Docket: 2026-2028 Electrical Corporation Wildfire Mitigation Plans
Docket# 2026-2028-Base-WMPs
Revision 1

SUBJECT: Response to SCE's 2026-2028 Base Wildfire Mitigation Plan (WMP) Revision Notice

Cover Letter Appendix A – Changes to Address Critical Issues

Cover Letter Appendix D – Responses to Critical Issues

Figure SCE-RN-SCE-26-09: SCE Anticipated Vegetation Management Remote Sensing Journey

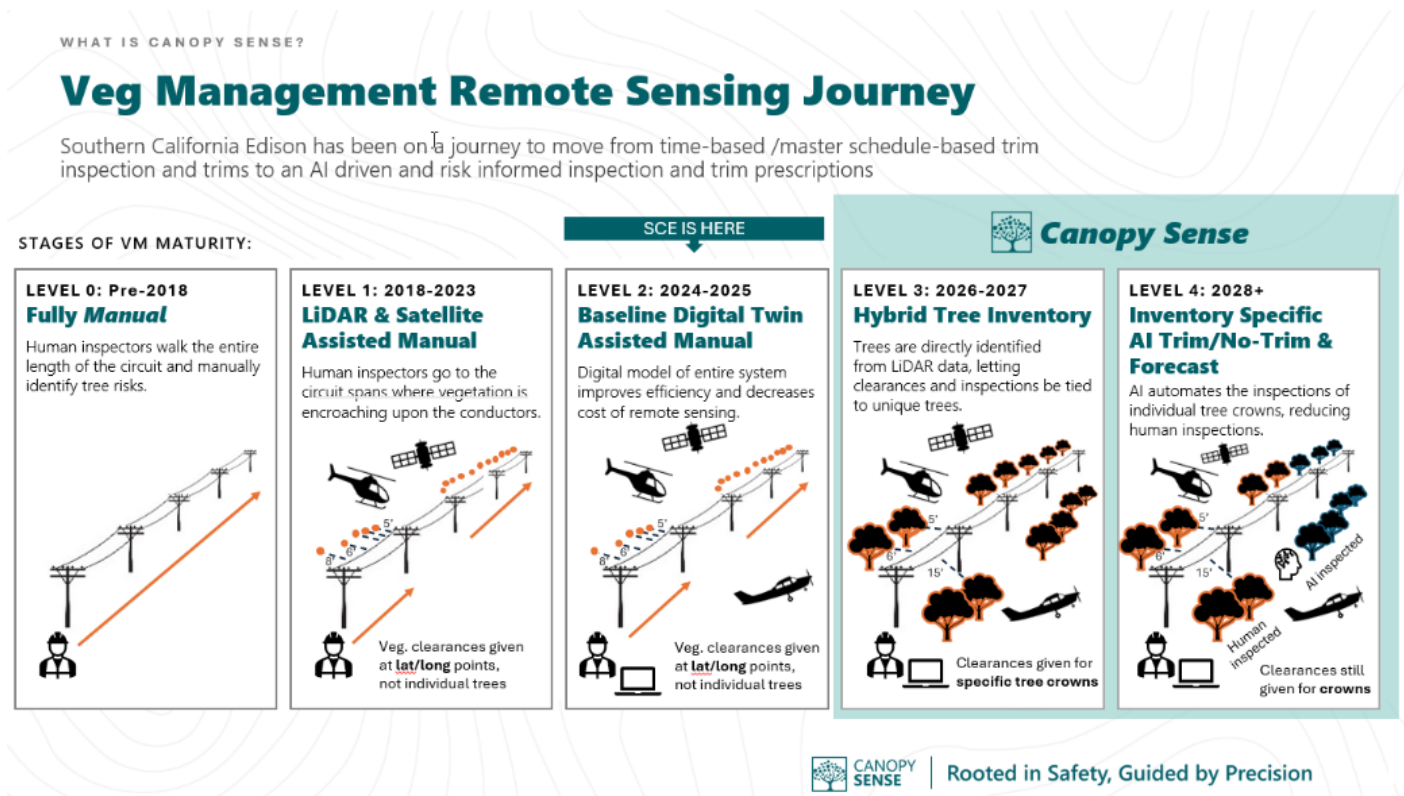
SCE must revise its 2026-2028 Base WMP to provide details on and discussion of its plans to transition from ground patrol inspections to remote-sensing technologies, including:

- *A description of how SCE plans to phase into remote sensing from ground-based patrol inspections, for years 2026, 2027, and 2028.*
 - *timeline, including measurable and auditable milestones, for the transition.*
 - *The timeline and milestones must be included in Table 9-1 as a qualitative target.*
- *A description of how and when SCE will perform ground-based patrol inspections in areas that have inconclusive remote sensing results or were not captured by remote sensing.*
- *Qualitative targets for mitigation activities the new VM-7 and VM-8 in Table 9-2 and correlating narrative consistent with SCE's response to Data Request 12, Question 1.*

SCE has added four new qualitative targets as shown in table SCE-RN-SCE-26-09 below to represent plans to phase in remote sensing inspections and to evaluate the effectiveness of remote sensing pilots. In section 9.2.1.6 in the revised WMP, SCE explains how ground-based inspections will be performed in areas that have inconclusive remote sensing results.
